Re: SE 3387, CMS Rockingham, Tankersley, Barnsley, South Yorkshire, S74 0SB

Condition 4 states the following:

Figure 1. Proposed lighting scheme supplied by Kingfisher Lighting

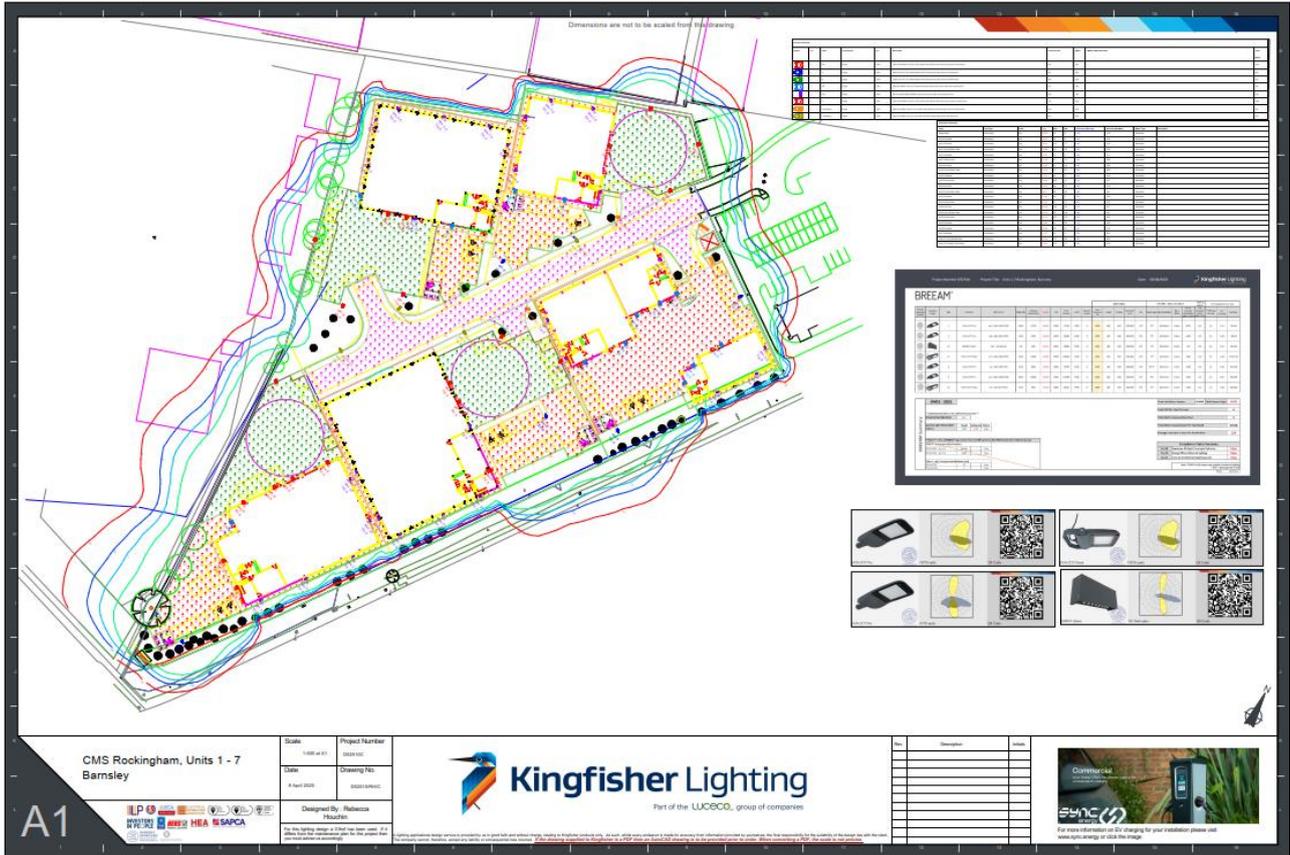
- All specified lamps are listed as having a colour temperature of 4000kelvin. This exceeds the stated 2700kelvin lamps recommended under current guidelines.
- Light spill onto sensitive habitats typically exceeds 5 lux within adjacent light-sensitive habitats. However, the scheme has been designed to achieve the health and safety requirement for safe illuminance of the associated car parking.
- All these units are confirmed to have a negligible Upward Light Ratio.
- No bollard or low-level downward-directional luminaires are to be incorporated into the lighting scheme.

Following review of the proposed light fittings the proposed lighting scheme conforms to the updated guidance (ILP & BCT, 2023) based on the universal use of LED luminaires with a negligible upper light output ratio (ULOR).

The position of on-site lighting has been designed to achieve minimum security and health & safety requirements for associated car parking and road infrastructure. In terms of light spill, the proposed lighting scheme does not conform to current guidance provided as projected light spill onto adjacent and on-site existing and proposed habitats exceeds 1 lux and are specified as utilising 4000k lamps rather than the recommended 2700k. However, lux levels associated with boundary and off-site features, such as street lighting and electronic signage, typically shed light within identified light-sensitive areas that exceeds this value significantly.

Overall bat activity following site survey in May 2025 determined use of western boundary habitats to be negligible to low. As result, the impact of the proposed lighting scheme deviations on the local bat community is expected to be negligible.
